A REPAIR

**ON-SITE SEWAGE DISPOSAL SYSTEM
HOWARD COUNTY HEALTH DEPARTMENT
BUREAU OF ENVIRONMENTAL HEALTH**

04-314050

ADDRESS: 2800 Duvall Road PROPERTY OWNER: Scott Carneal

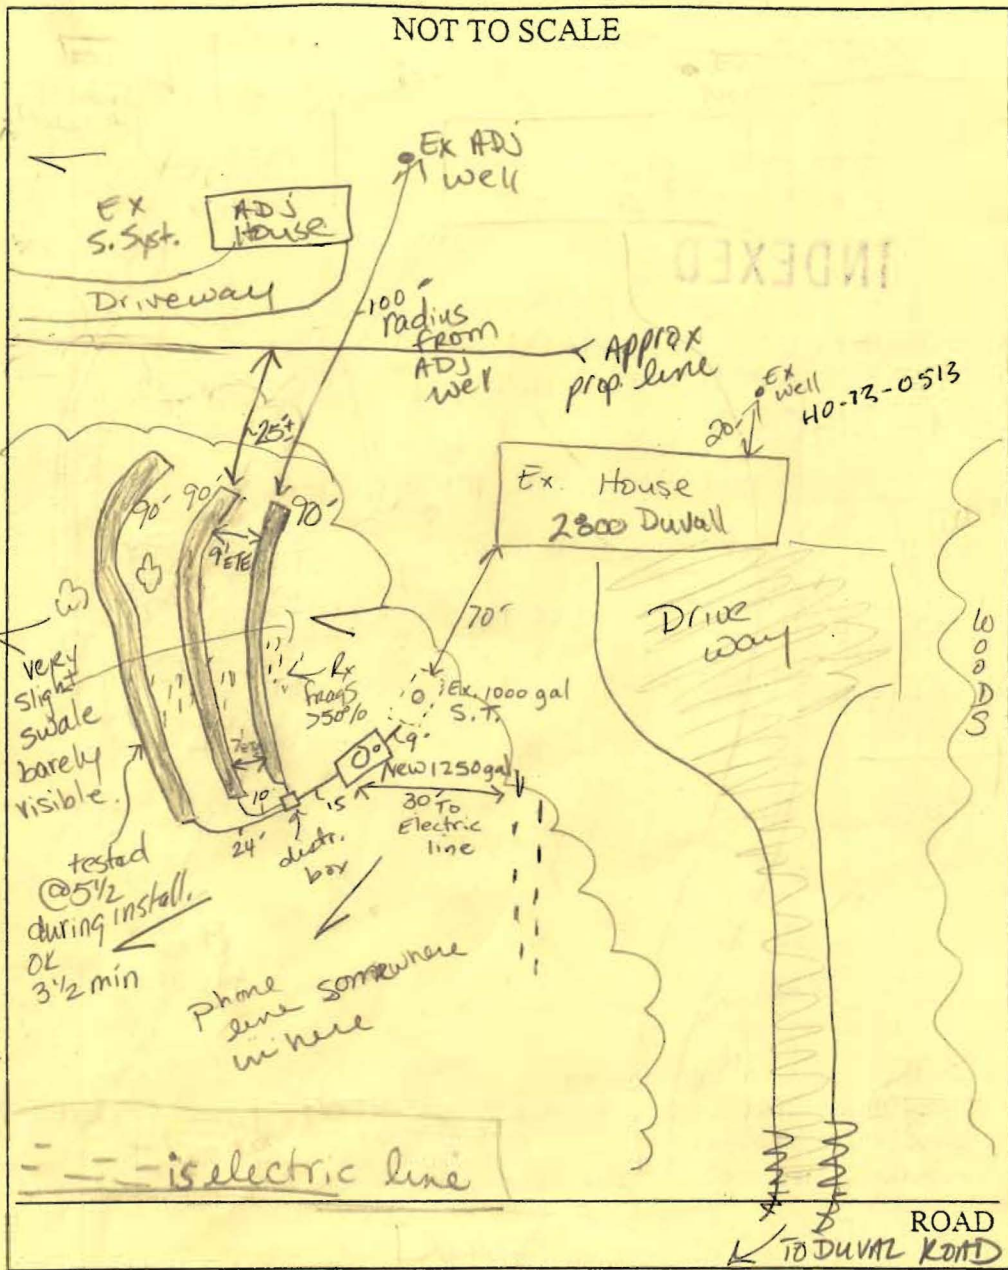
TRENCHES:	Trench to be 3 feet wide. Inlet ^{1 1/2'} feet below original grade. Bottom maximum depth ^{2 1/2'} feet below original grade. Effective area begins at 2' feet below original grade. 1 foot of stone below distribution pipe.
LOCATION:	Cave in existing dry well. ADD 1250 tank to system. Run 3-90' trenches on contour.
PURPOSE:	Septic system has failed. Call for inspection when ground is opened so sanitarian can recommend repair. Clogged line - and in support of building permit.

PRE-CONSTRUCTION 5-7-03 Dry well effluent measured 10' below surface. Bottom of Dry Well is @ 11' - must be too much R - should

INSTALLATION be saturated by now. Dug holes A + B, >80% Rock starting at 2 1/2'. Downslope of Hole A by 10' perched at 3 1/2' corner + hole C perc at 4 1/2' and 2'. SEE SOIL PERC SHEET. No

surrounding well concerns downslope. Install trenches approximately 30-35' downslope of S. Tank (KN) 5-12-03 Inspector

there all day. OK TO COVER ALL TRENCHES. NEED TO INSPECT d. box for water test, levelers, and appropriate baffle. Existing

dry well collapsed + filled in. (KN) 5-19-03 D. Box covered. Called

Skip on cell. STD levelers USED + cinder block cut 1/2" (KN)
